Value Engineering Study

Final Report

Kentucky Transportation Cabinet I-71 Widening, MP 14.1 to MP 18.0 Oldham County

Item No. 5-483.10

VALUE ENGINEERING PROPOSAL NO. 3

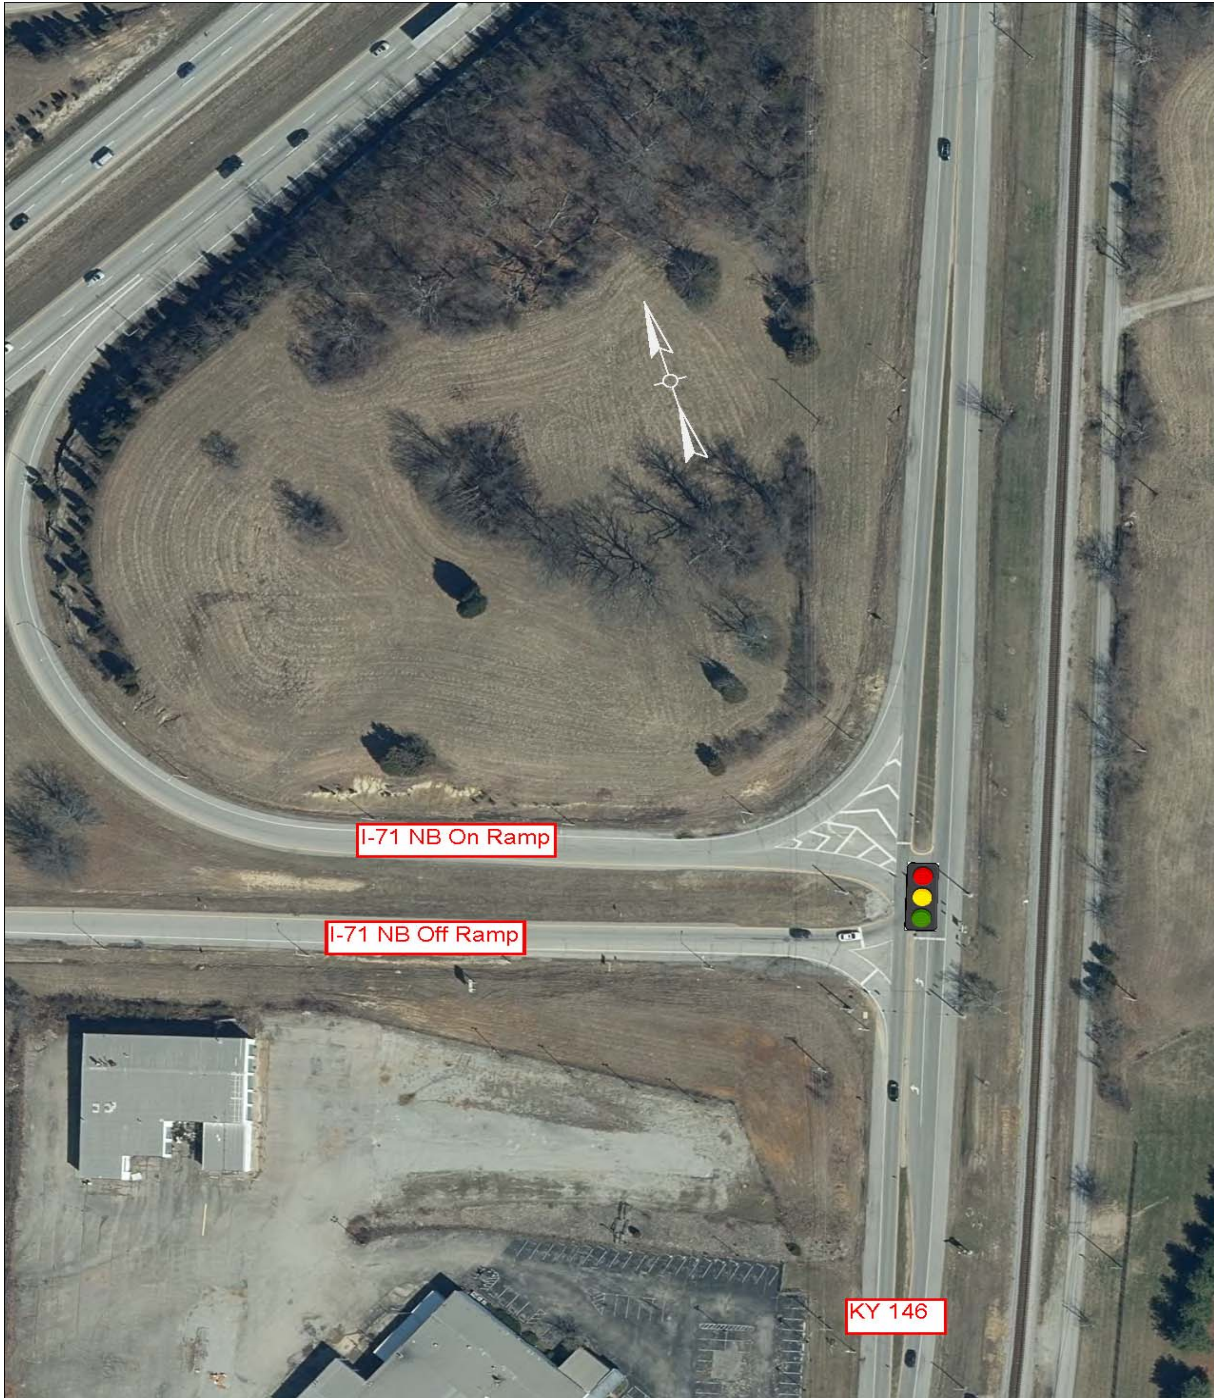
TITLE	Review capacity and safety options for KY 146		
FUNCTION	Enhance Connectivity		
VE PROPOSAL SYNOPSIS:			
Provide low cost improvement options which would improve capacity, functionality, and prevent crashes by constructing a continuous Green-T intersection which includes a Partial Median U-Turn on KY 146 and square up turn radius involving I-71 northbound and southbound ramps onto KY 146.			
 Reliability	Improved	 Functionality	Improved
 O&M	Maintained	 Schedule Impact	Maintained
			\$ Initial Cost Avoidance (Add)
			(\$255,000)
BASELINE CONCEPT DESCRIPTION:			
A No-Build with Install Signal at Southbound Ramp Terminal alternate at the I-71 @ KY 146 intersection. This alternate includes installing a signal at the I-71 Southbound Ramps at KY 146 intersection which is currently stop controlled on the ramps. The I-71 Northbound Ramps at KY 146 is currently signalized.			
VE PROPOSAL DESCRIPTION:

The value team analyzed five options for the I-71 @ KY 146 Intersection: (Option A) constructing a Continuous Green-T intersection, (Option B) constructing a Partial Median U-Turn, (Option C) tightening and square up the right turn radius for the right turns from the I-71 Northbound and Southbound Off Ramps, (Option D) install oversized "Do Not Enter" and "Wrong Way" Signs with Red Reflective Panel strips on posts, and (Option E) constructing a double roundabout.			
VE PROPOSAL ADVANTAGES:		VE PROPOSAL DISADVANTAGES:	
● Increased safety by reducing serious injuries and potential fatal crashes		● Public Perception regarding the partial median U-turn (Atypical movement)	
● Potential increase to capacity		● Potential impacts to utilities	
● High Function vs Low cost value		● Potential impacts contributed to the partial median U-turn	
●		● Creates a merge/weave traffic pattern	
●		●	
●		●	
●		●	
●		●

Recommendation: The VE Team believes we may be able to provide low cost improvement options which would improve capacity and prevent crashes. The value team analyzed the following options within this general concept:	
Option A – Construct a Continuous Green-T (CGT) intersections for I-71 Northbound @ KY 146 Intersection Option B – Construct a Partial Median U-Turn for KY 146 Northbound Left Turns onto I-71 Northbound Option C – Tighten and square up the right turn radius for the right turns onto KY 146 from the I-71 Northbound and Southbound Off Ramps Option D – Install oversized "Do Not Enter" and "Wrong Way" Signs with Red Reflective Panel strips on posts. Option E – Construct a double roundabout at the KY 146 Interchange, utilizing a single-lane roundabout	
The recommended concept as mentioned above shows five different options to consider at this intersection.	
Option A was considered because the value team believed this proposal would help increase capacity and improve safety at the I-71 Northbound and KY 146 Intersection. Constructing a CGT intersection would allow KY 146 Northbound Thru vehicles (375 vehicles for 2019 PM Peak Hour) to have a continuous green signal and become free flow movement. Using the Capacity Analysis for Planning of Junctions (CAPx), constructing CGT intersection would improve volume to capacity ratio from 0.58 for the existing signal to 0.43 for the CGT in 2019 Design Year. For the 2045 Design Year, the volume to capacity ratio for the signal is 1.01 and the CGT is 0.81. Using the Safety Performance for Intersection Control Evaluation (SPICE), the CGT is predicted to reduce Fatal and Serious Injury Crashes by 15%.

TITLE	Review capacity and safety options for KY 146
DISCUSSION & JUSTIFICATION (continued):	
<p>The VE Team recommends further evaluation of the Option A, Option B, Option C, and Option D.</p>	
<p>The VE Team did not specifically analyze the I-71 Southbound at KY 146 intersection, but some of these improvement options can be implemented at that intersection. Such as squaring up the right turn lanes on the off ramp and preventing wrong way drivers</p>	
<p>Cost:</p>	
<p>Cost Considerations with recommending Option A, Option B, Option C, Option D show a total estimating \$255,000.</p>	
<p>The four main cost factors in this total includes: Full depth pavement-BASE, removing and replacing light poles, FG 300 Curb System, and miscellaneous costs associated with striping, signing, and removal (which can be seen below). All other costs included are relatively minor in the grand scheme of overall costs.</p>

VALUE ENGINEERING PROPOSAL NO. 4

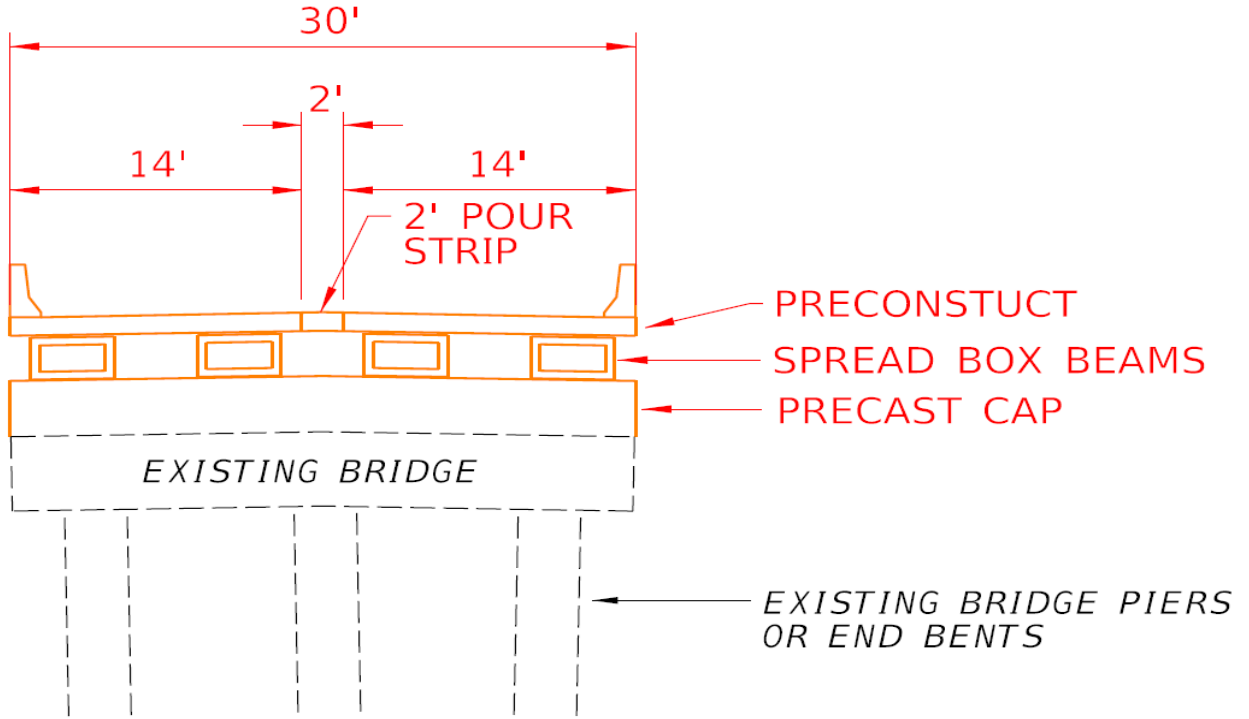
TITLE	Utilize ABC Construction to keep Glenarm Rd. at same location using existing substructures		
FUNCTION	Enhance Connectivity		
VE PROPOSAL SYNOPSIS:			
Reconstruct the Glenarm Rd. overpass (superstructure only) on the existing tangent alignment reusing existing substructures.			
 Reliability	Maintained	 Functionality	Maintained
 O&M	Maintained	 Schedule Impact	Improved
			\$ Initial Cost Avoidance (Add)
			\$1,040,000
BASELINE CONCEPT DESCRIPTION:			
Glenarm Rd. is relocated on a new parallel alignment so piers and end bents are fully reconstructed and new approach roads are needed, with each constructed along reverse curves. Right-of-way purchase is required to construct the new approach roads.			
VE PROPOSAL DESCRIPTION:			
Reconstruct superstructure on existing piers and end bents, raising the cap elevations to achieve 16'-6" minimum vertical clearance. Accelerated Bridge Construction (ABC) will be utilized to minimize Glenarm Rd. closure time due to 8-mile detour.

The existing 240-ft, 4-span (50'-70'-70'-50') RCDG bridge has haunched girders that do not allow adequate clearance for the widened I-71 template so the bridge needs to be reconstructed to provide the required clearance. The primary reason for the baseline alternate to reconstruct Glenarm Rd. along a new alignment is due to the 8-mile detour .if constructed along the existing alignment, the user cost/inconvenience could be significant due to the bridge having to be closed for a long time.

TITLE	Construct short-term, low cost improvements at KY 329
-------	---

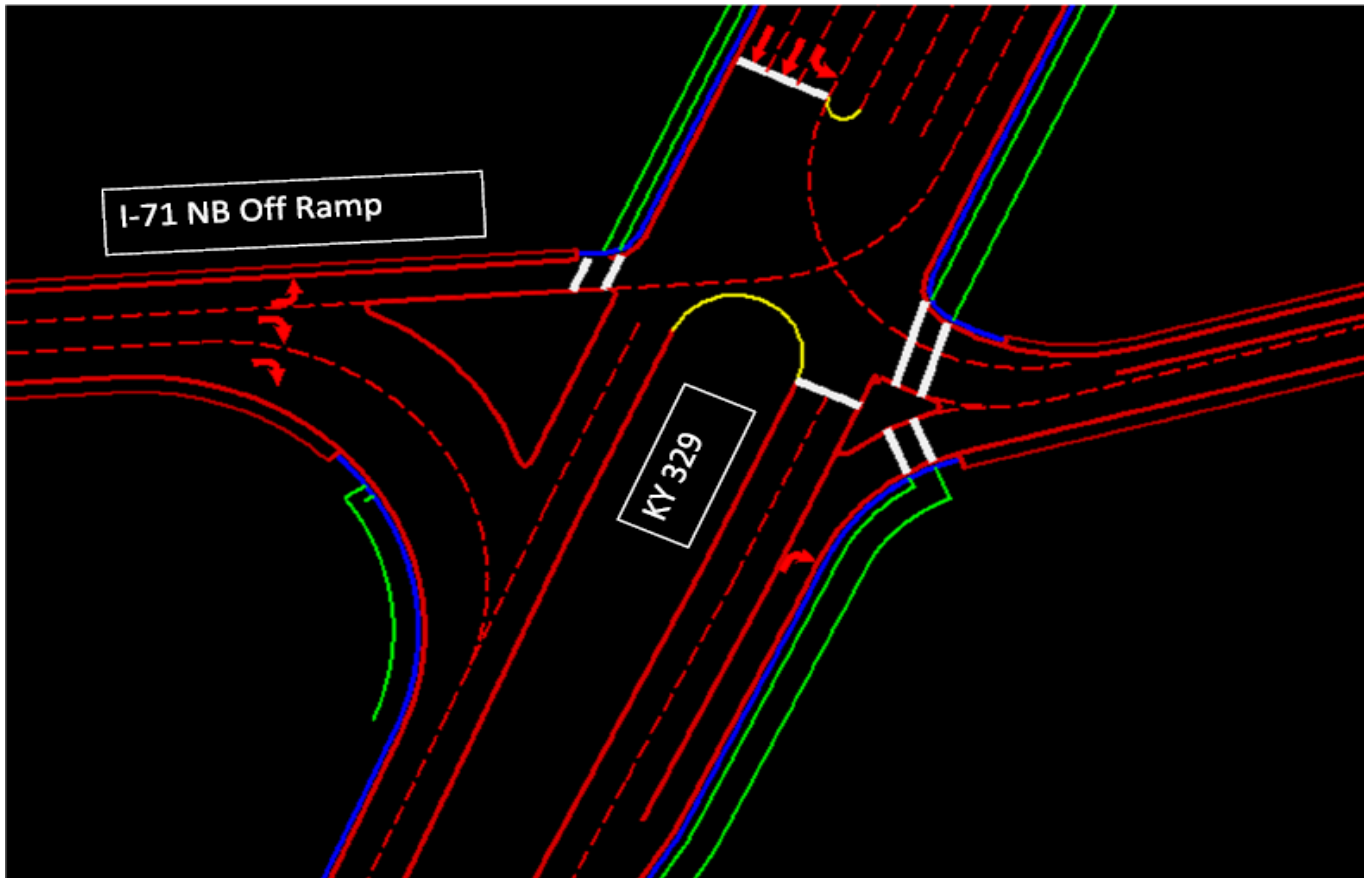
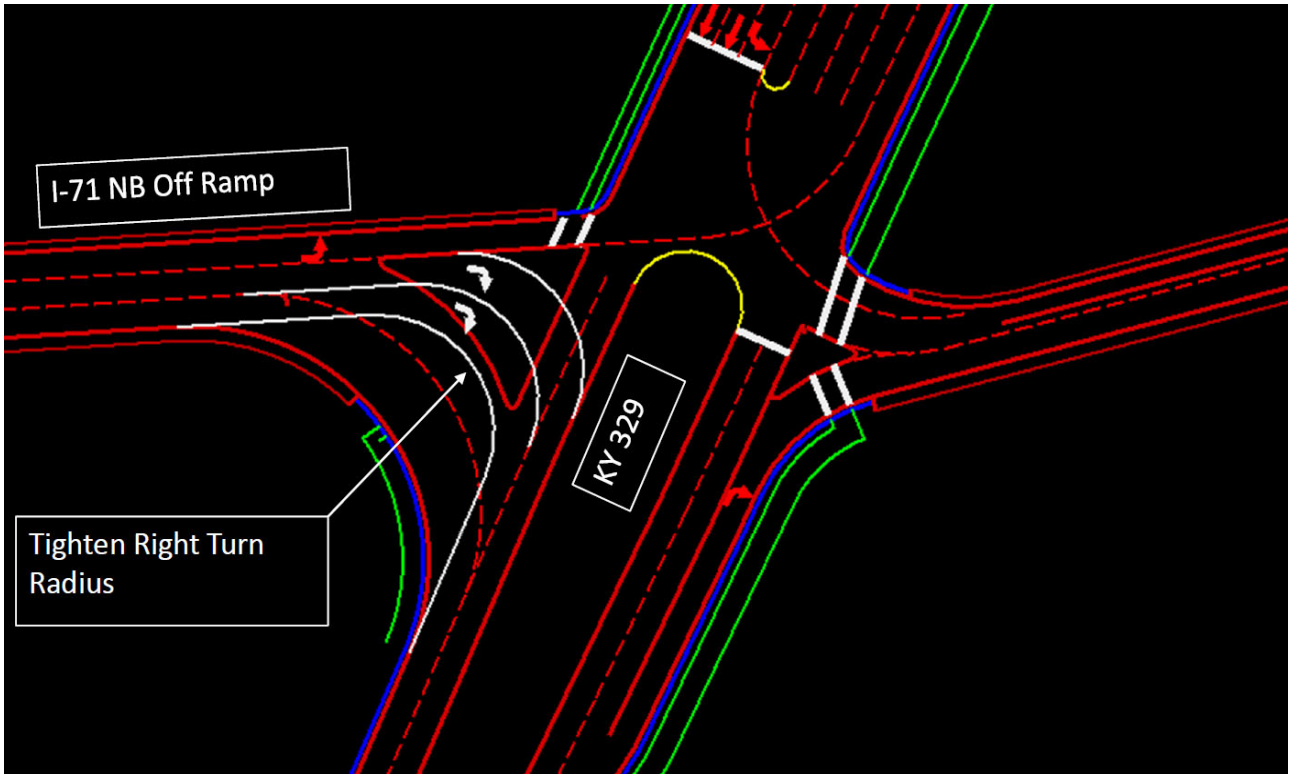
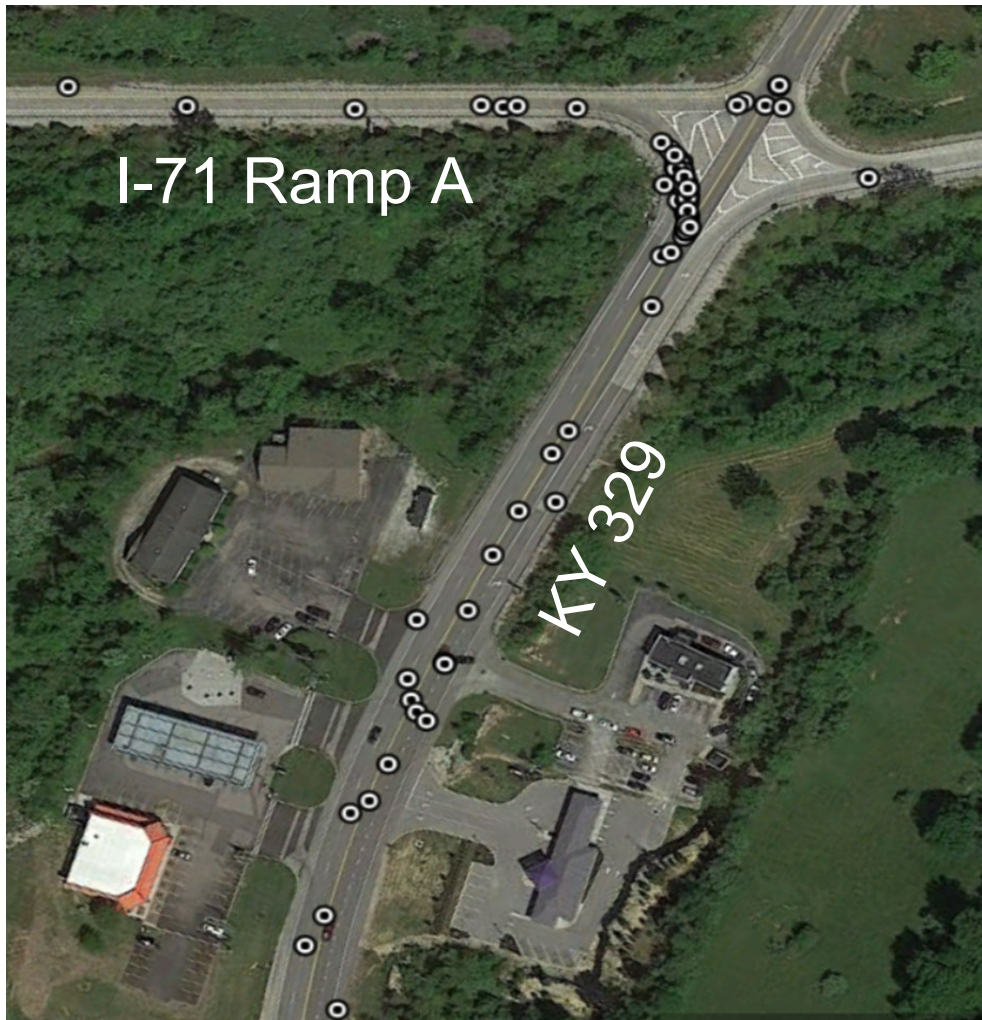
TITLE	Construct short-term, low cost improvements at KY 329		
FUNCTION	Separate Traffic		
VE PROPOSAL SYNOPSIS:			
Provide short-term, low cost improvement options which would improve capacity and prevent crashes at the I-71 and KY 329 Interchange. These improvement options include constructing single lane roundabout, squaring up the right turn lane radius from ramps to KY 329, adding a right turn added lane onto KY 329 from I-71 Northbound off ramp, and access management along KY 329.			
 Reliability	Improved	 Functionality	Improved
 O&M	Maintained	 Schedule Impact	Maintained
			\$ Initial Cost Avoidance (Add)
			(\$4,000)
BASELINE CONCEPT DESCRIPTION:			
KY 329 has two lanes in each direction with multiple turn lanes at the I-71 ramp terminals. Traffic signals will be constructed at the ramp terminals.			
VE PROPOSAL DESCRIPTION:			
Construct low cost improvements to KY 329 interchange. Squaring up the right turns, added a right turn lane from the off ramp, and access management can all be incorporated with the Baseline Concept. The single lane roundabout may be implemented for the design year until the traffic exceeds what the single lane roundabout can handle.

VALUE ENGINEERING PROPOSAL NO. 6

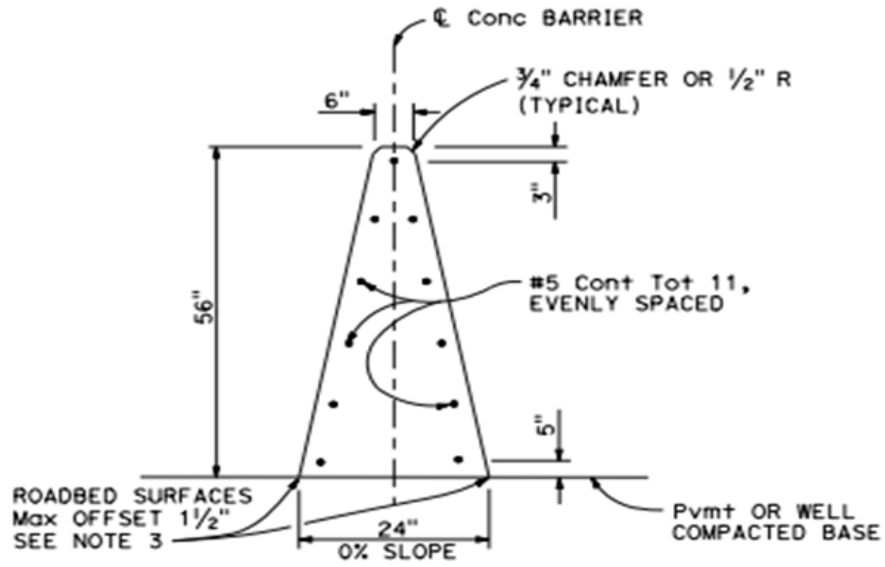
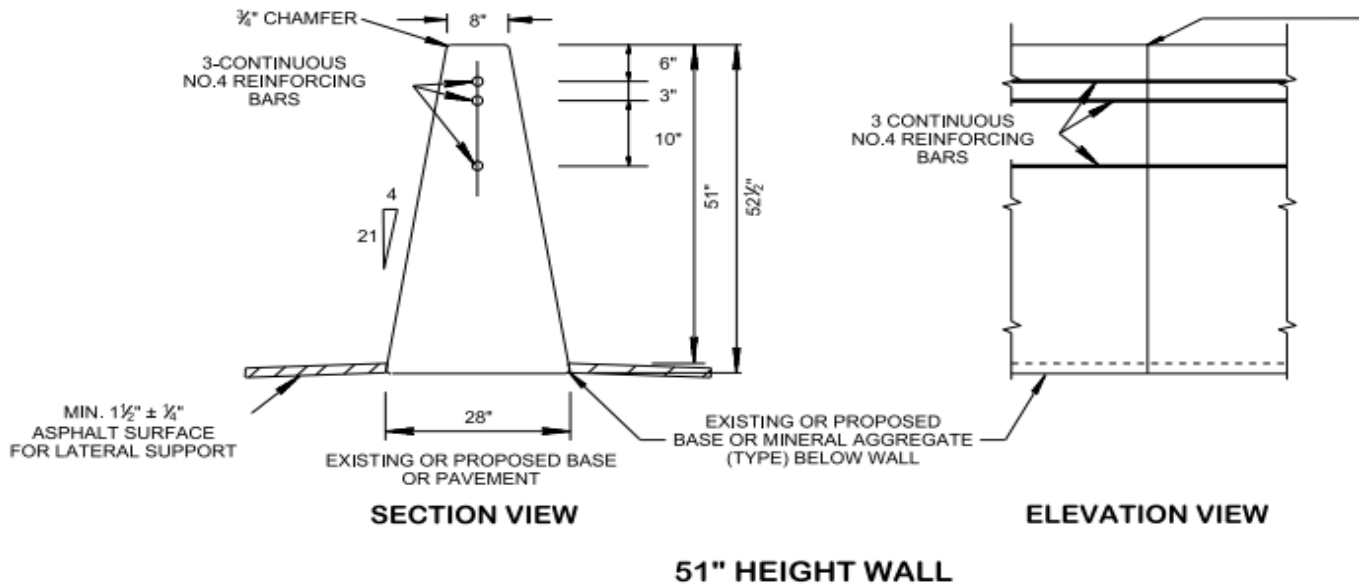
TITLE	Construct Class IV wall in lieu of Class V wall		
FUNCTION	Separate Traffic		
VE PROPOSAL SYNOPSIS:			
In a scenario where full median shoulders are provided, it is suggested KYTC consider TL 4 concrete median barrier. The TDOT wall takes approximately 21% less concrete to construct. Reinforcement steel was considered to be equivalent. Maintenance life cycle costs for either concrete median barrier are considered equal.			
 Reliability	Maintained	 Functionality	Maintained
 O&M	Maintained	 Schedule Impact	Maintained
			\$ Initial Cost Avoidance (Add)
			\$97,000
BASELINE CONCEPT DESCRIPTION:			
KYTC has indicated to use KYTC Barrier wall 12C per the standard drawings in the cost estimates provided, but the shape of this wall is not MASH compliant. It has been mentioned in previous projects that a 56-inch tall TL 5 concrete median barrier should be used to take the place of Type 12C.			
VE PROPOSAL DESCRIPTION:

Consider use of 51-inch tall TL 4 concrete median barrier, especially in areas with wider medians and shoulders.			
VE PROPOSAL ADVANTAGES:		VE PROPOSAL DISADVANTAGES:	
● Cost savings for materials		● Minor reduction in crash performance	
●		●	
●		●	
●		●	
●		●	
●		●	
●		●	
●		●	
\$ COST SUMMARY	Initial Costs	O&M Costs	Total Life Cycle Cost
BASELINE CONCEPT:	\$539,000	\$0	\$539,000
VE PROPOSAL:	\$442,000	\$0	\$442,000
TOTAL (Baseline less Proposed)	\$97,000	\$0	\$97,000
			AVOID COST

Detail from Caltrans Standard Plans. The Type B wall as detailed in the Preliminary line and grade plans has a base of 32" wide and a top projected to be 10.75" wide (based on constant slope of TDOT wall).
